U.S. ARMY CORPS  
OF ENGINEERS

VALUE ENGINEERING STUDY

**SOUTHEAST LOUISIANA  
FLOOD CONTROL,  
ORLEANS PARISH, LA**

**DRAFT REPORT**

DRAWING NO. 3

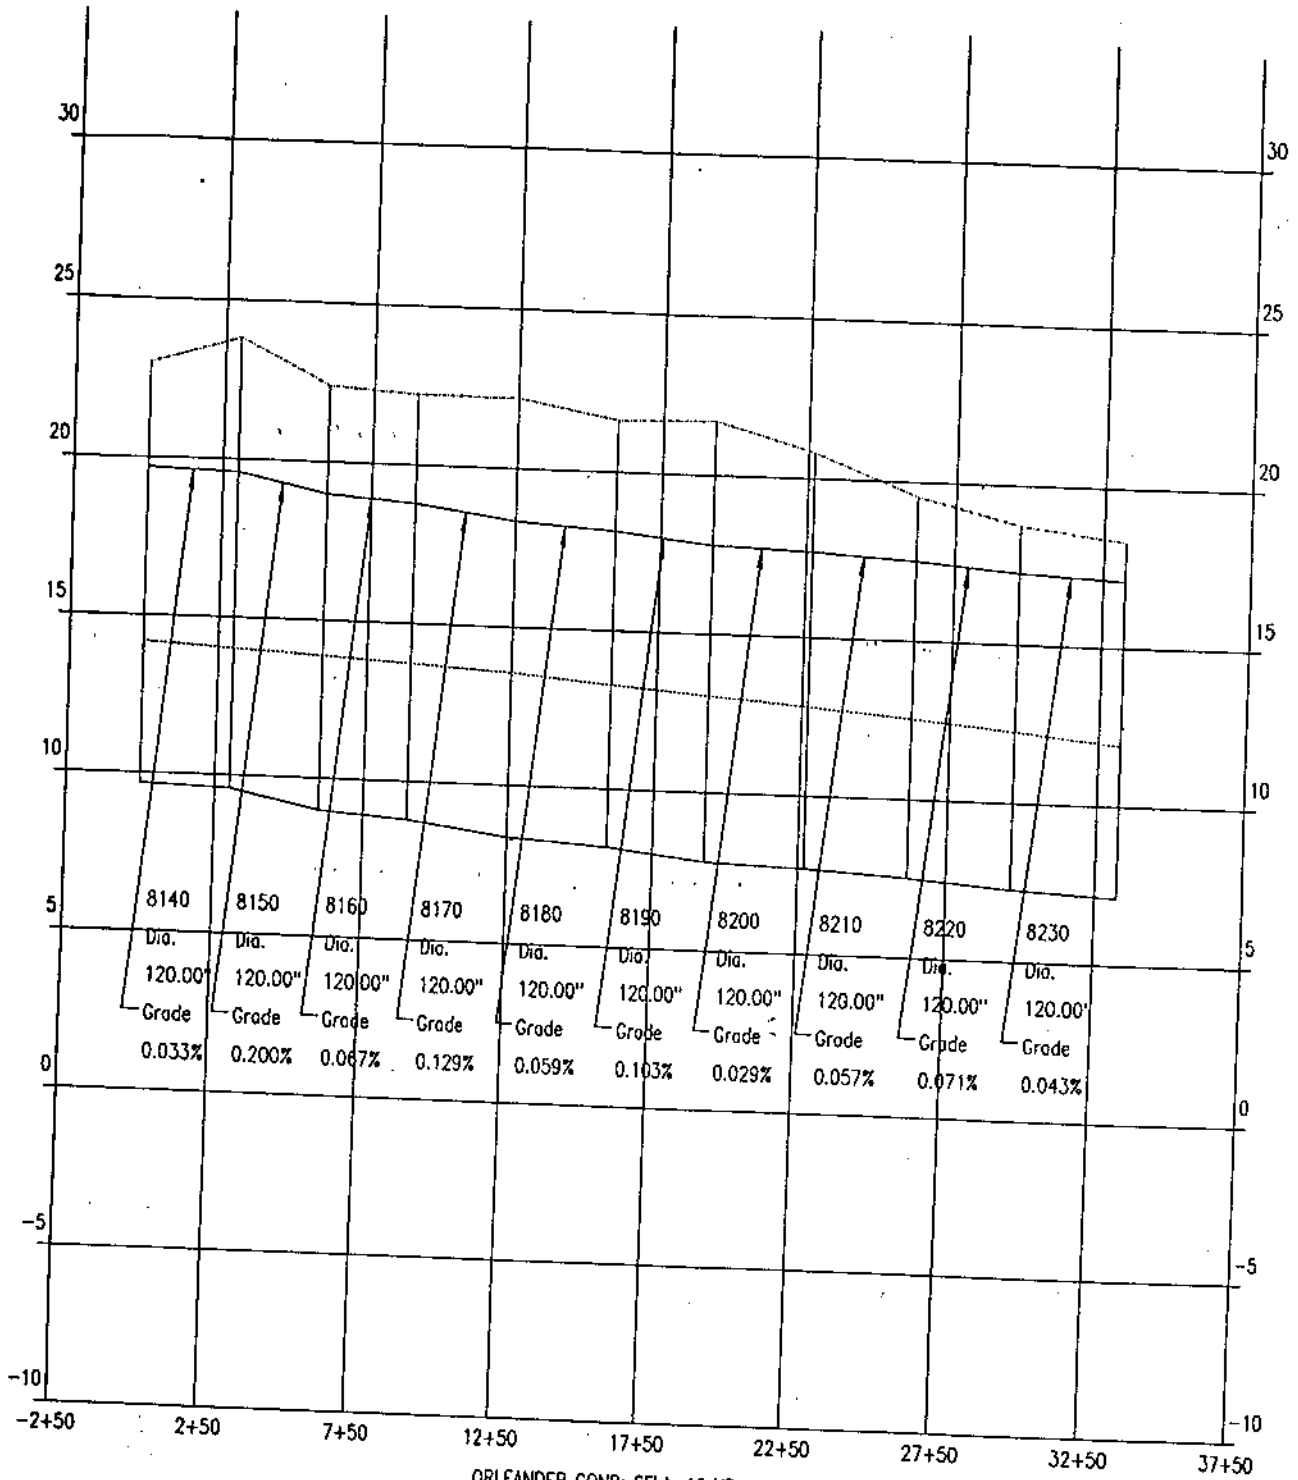
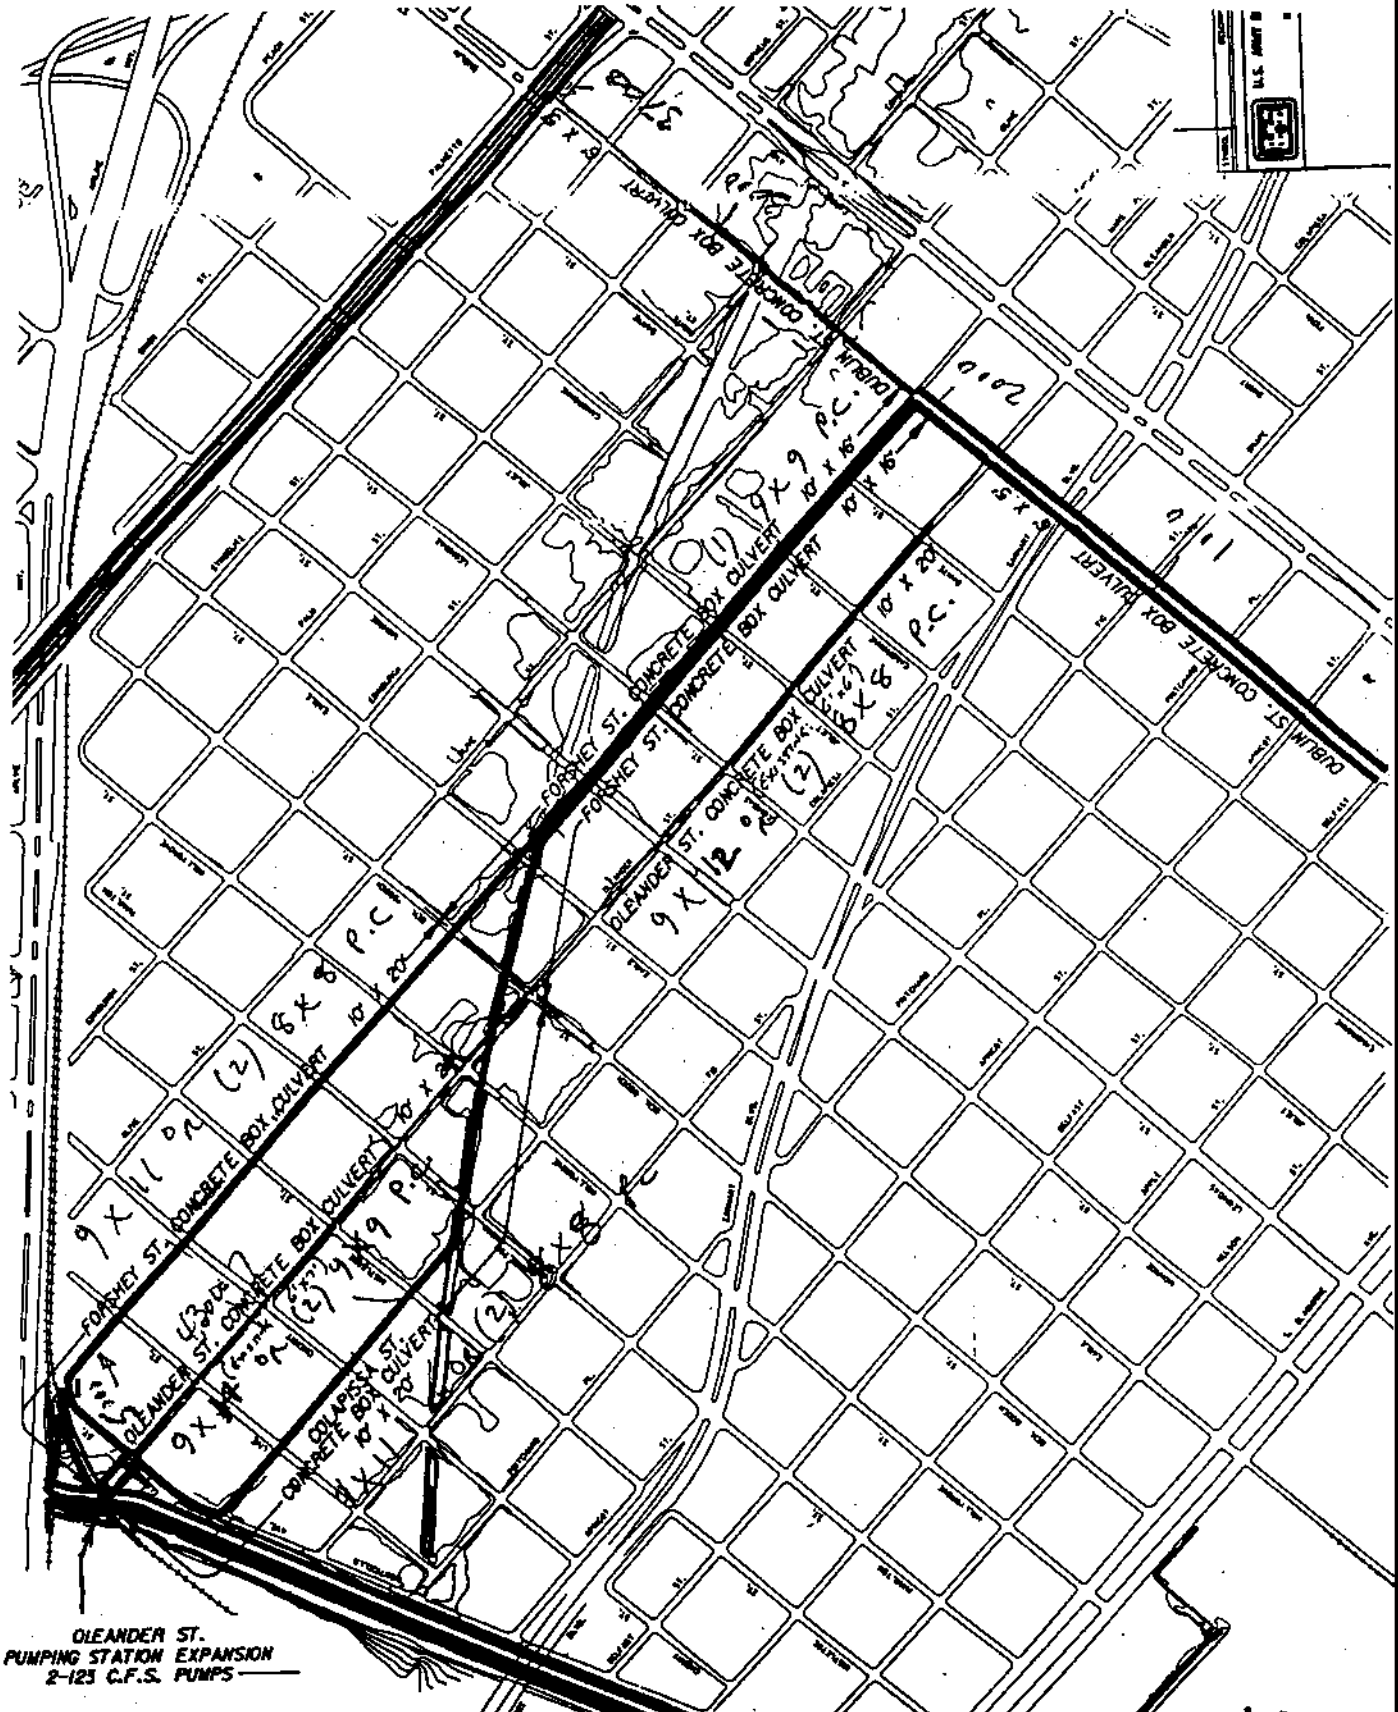
(See Drawing No. 3.) This drawing, along with the table below, depicts the proposed culvert optimization:

<u>PROPOSAL</u>	<u>ALIGNMENT</u>	<u>REPLACES CIP BOX CULVERT</u>	<u>WITH</u> (CIP = Cast-in-Place; PC = Pre-Cast)
3A	Oleander	10 X 20 & 10 X 24	9 X 14 & 9 X 12 CIP
3B	Forshey	10 X 20 & 10 X 16	9 X 11 CIP & 9 X 9 PC
3C	Oleander	10 X 20 & 10 X 24	Two 9 X 9 & 8 X 8 PC
3D	Forshey	10 X 20 & 10 X 16	Two 8 X 8 PC & One 9 X 9 PC

DRAWING NO. 1

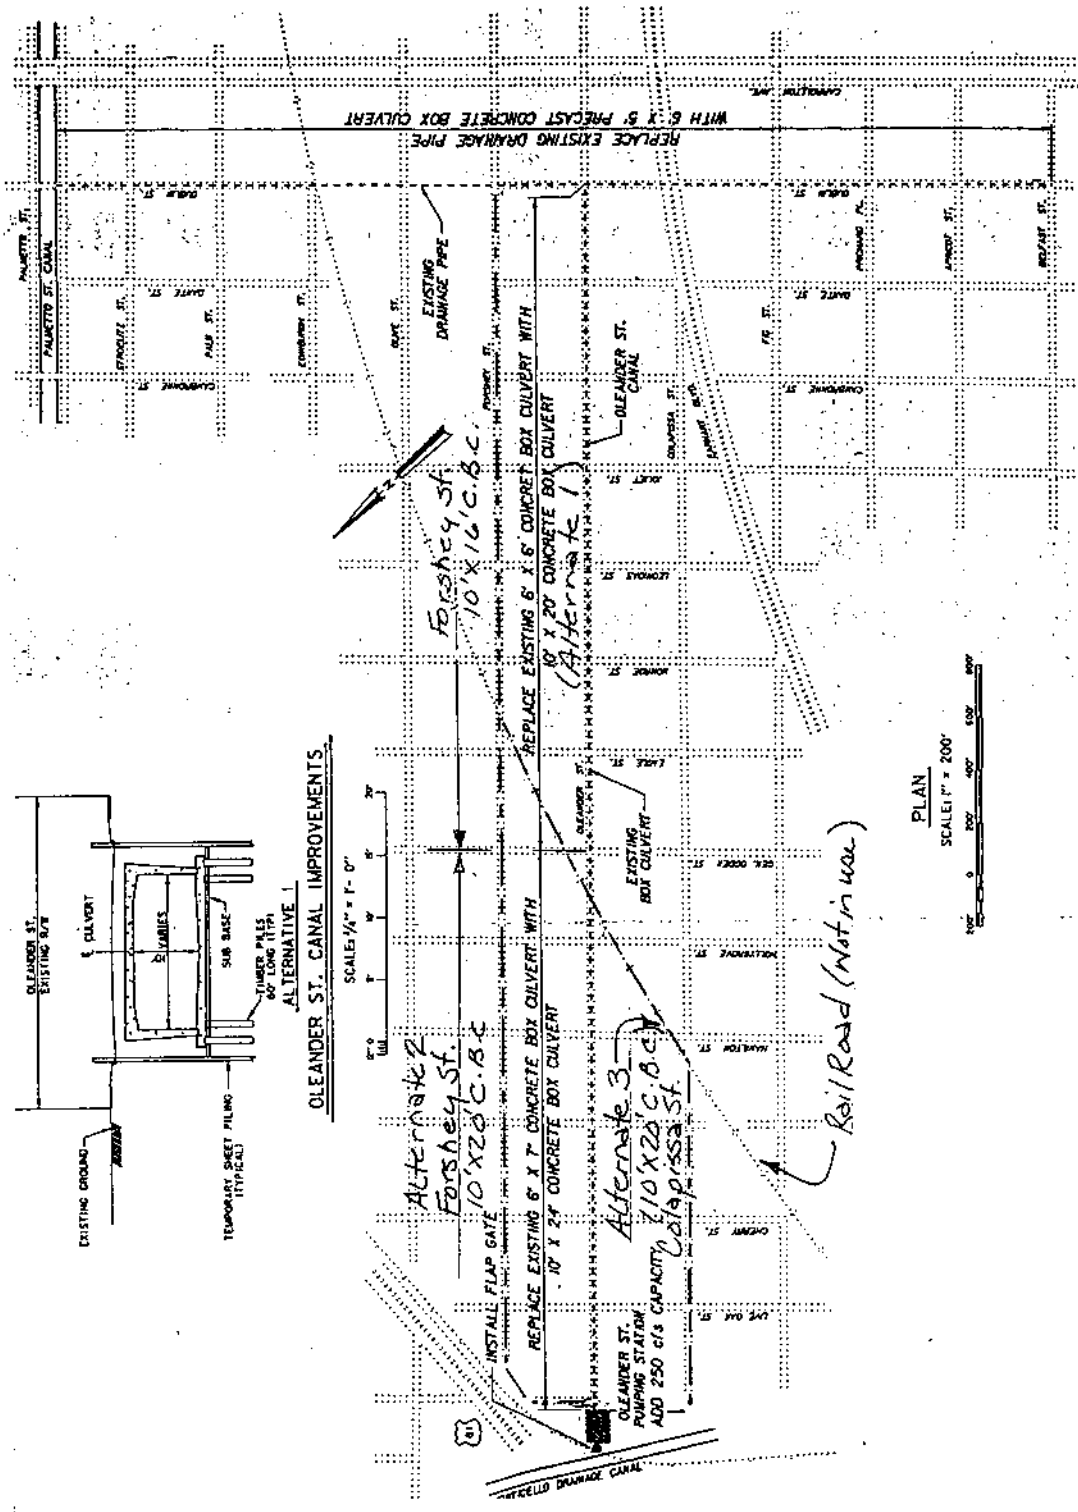
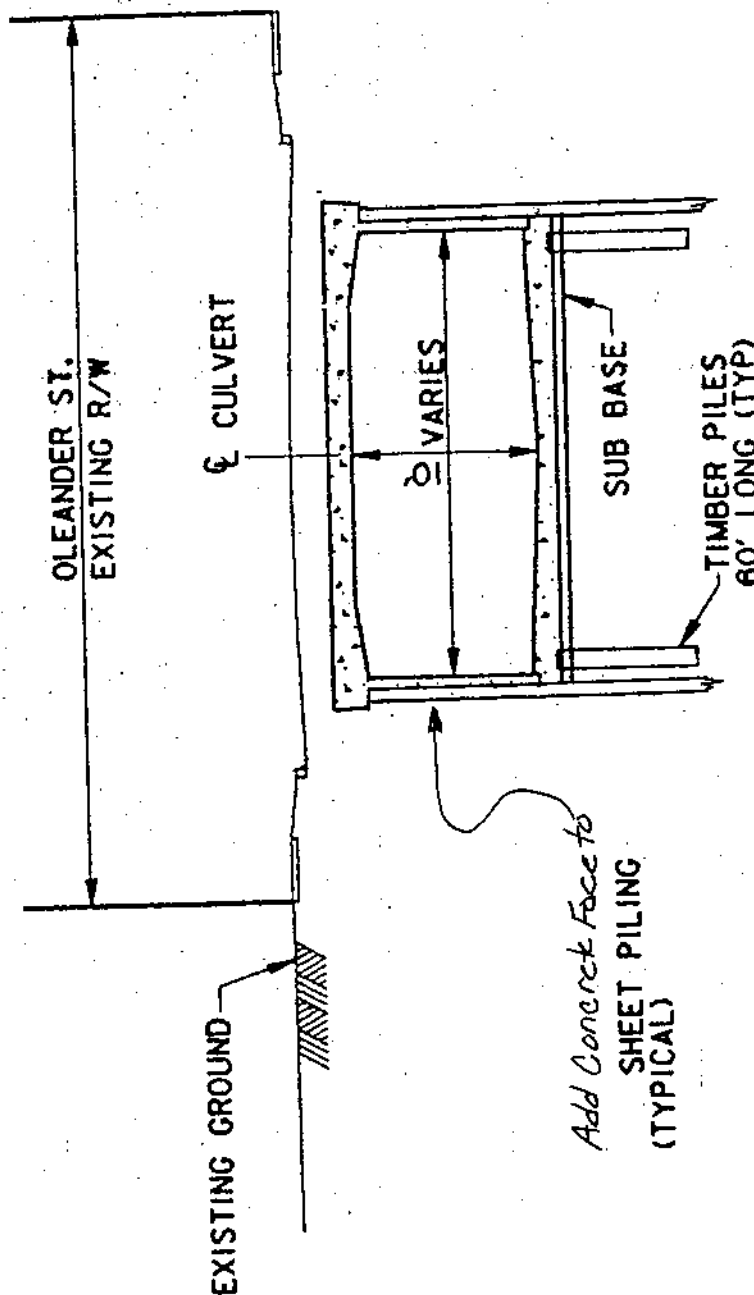
The current plan provides piled founded concrete box culverts for approximately 4,650 LF along Oleander Street (10' X 20' or 10' X 24' CBC). Shoring for excavation will include steel sheet pile off-set approximately 4' behind culvert walls to facilitate forming and casting of reinforced concrete walls. Two alternative alignments are being considered using Forshey Street to Livingston/Monticello Alternative 2 (4,950 LF) or Forshey to Eagle Street, then along the former railroad right-of-way to Colapissa Street Alternative 3 (5,100 LF). The two later alternatives are smaller as Oleander's existing box culvert remains in place. (See Drawing No. 1.)

It is recommended that an alternative box culvert design be developed using steel sheet pile walls with concrete facing and a concrete slab invert along with a reinforced concrete top. Box culvert size will match the selected alignment alternatives 1, 2, or 3 (see Drawing No. 2).

## DRAWING NO. 1

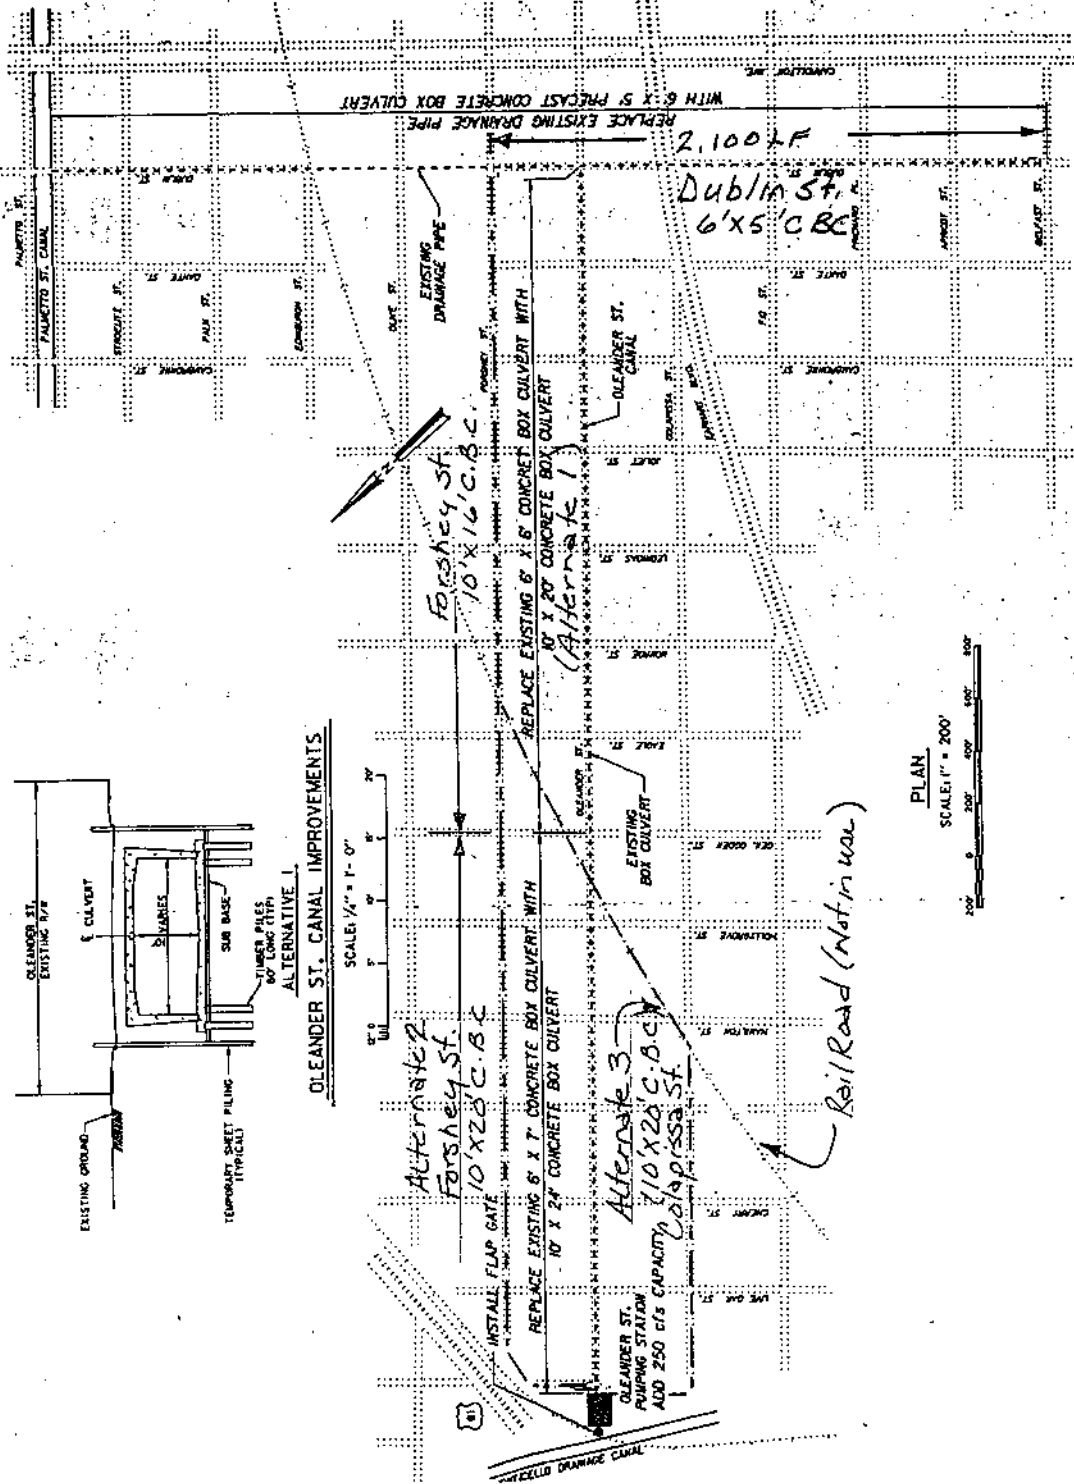
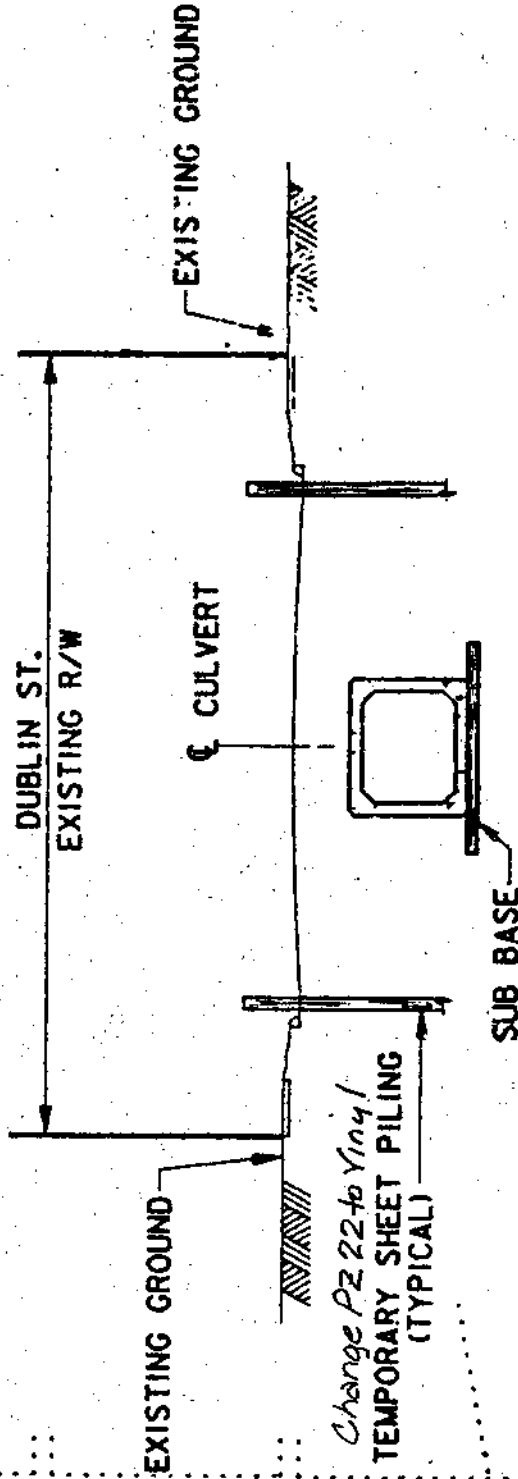
The current construction plan for excavation and construction of concrete box culverts and provides shoring of excavations using PZ-22 steel sheet pile. The current plan identified a 6' X 5' pre-cast box culvert for Dublin Street (3,700 LF). (See Drawing No. 1.)

It is recommended that vinyl sheet pile be used for excavation shoring in lieu of PZ-22 steel sheet pile. The vinyl sheet pile option serve as shoring and support dewatering during construction. Vinyl sheet pile can be driven and remain in place (no pulling for re-use).

## DRAWING NO. 1

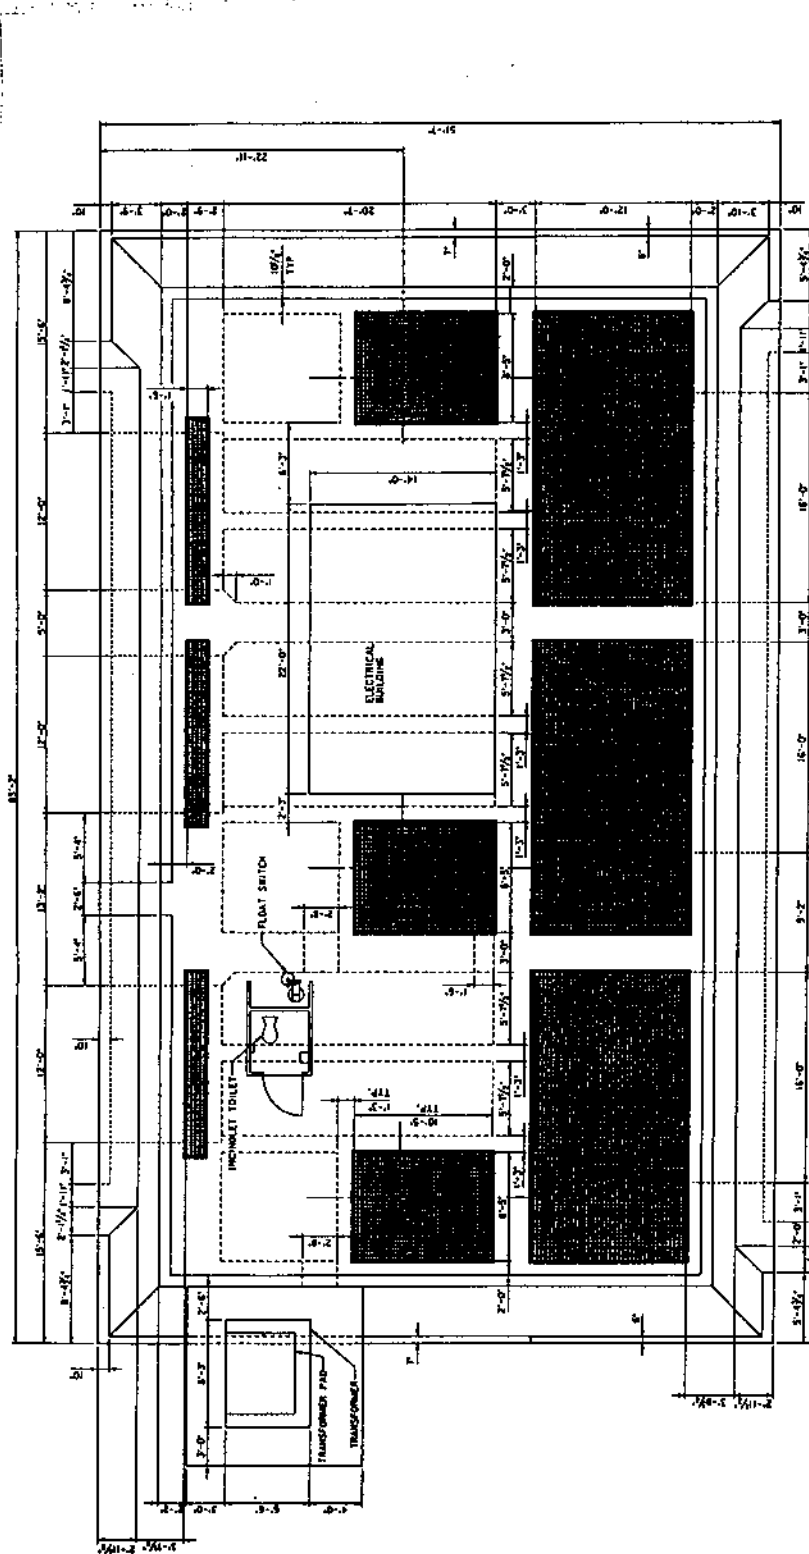
The current design concept calls for the addition of two 125 CFS vertical lift pumps to the existing Oleander Pump Station. Drawing No. 1 depicts the existing pump station plan. The placement of the two proposed additional pumps is not shown. These additional pumps increase the Oleander pump capacity to 350 CFS.
